VILLAGE OF EAST TROY

ORDINANCE 2022-10

**AN ORDINANCE TO AMEND CHAPTER 510 OF THE VILLAGE OF
EAST TROY MUNICIPAL CODE RELATING TO DRIVEWAY
DESIGN AND TURNING MOVEMENTS IN PARKING LOTS**

Figure 1.

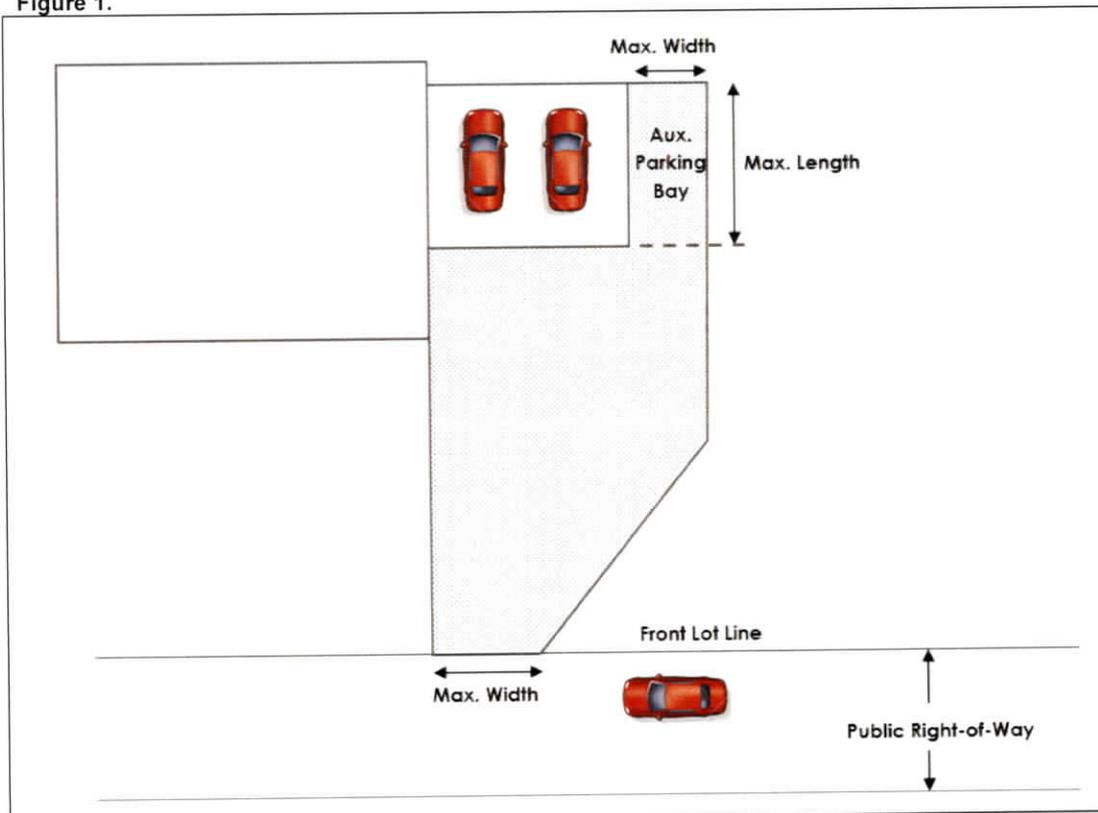
Section 2. Repeal and recreate Figure 1 in Section 510.91.1 as depicted below.

- (1) The maximum width of the driveway at the right-of-way line is 24 feet.
- (2) A driveway may include a taper starting at the front lot line provided the angle of the taper does not exceed 135 degrees.
